UNITED STATES PATENT AND TRADEMARK OFFICE

Office Action Summary

10/550,811

DETAILED ACTION

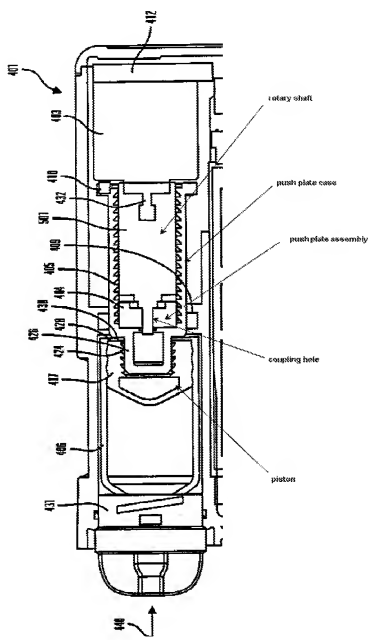
pushing the piston, the push plate assembly having a disk part (405 that intersects with 410) having a male screw formed on the outer circumferential surface thereof and a coupling hole (404 – see annotated drawing in response to arguments) axially coupled with the rotary shaft at the central portion thereof to allow for forward and backward movement of the rotary shaft and to transfer rotation of the rotary shaft (Fig 4-7a), which passes through the coupling hole; and a hollow cylindrical type push plate case inserted into the injector receiving space of the rear end of the syringe (Figs 4-7a), for the piston to pass therethrough, the push plate case having a female screw (404 – see annotated drawing in response to arguments) formed on the inner circumferential surface thereof to be coupled with the male screw of the disk part for allowing the disk part to carry out a spirally forward and backward movement (Figs 4-7a); wherein the piston (407) has a hollow cylindrical body having the closed front end and the opened rear end, and wherein the push plate assembly includes: the disk part (405 that intersects with 410), a hollow cylindrical type idle rotation sleeve (Figs 4-7a) protruding from the surface of a side of the disk part; and, a hollow cylindrical type fixed sleeve inserted into the outer circumferential surface of the idle rotation sleeve (432) carry out the idle rotation, the outer circumferential surface of the fixed sleeve being fixed to the inner circumferential surface of the rear end portion of the piston (Figs 4-7a). Additionally, see response to arguments below.

19. The Examiner directs the applicant to the following annotated Figure 4 of McConnell:

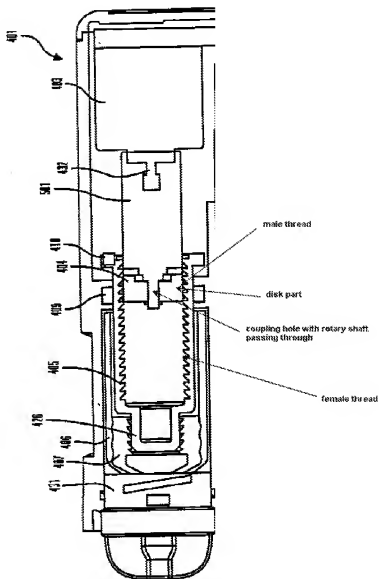
18. The applicant argues that the drive screw in McConnell includes a screw on the outer surface and fails to include a female screw formed on the inner circumferential surface thereof.

23. Thus, the Examiner notes that McConnell clearly discloses a female screw formed on the inner circumferential surface.
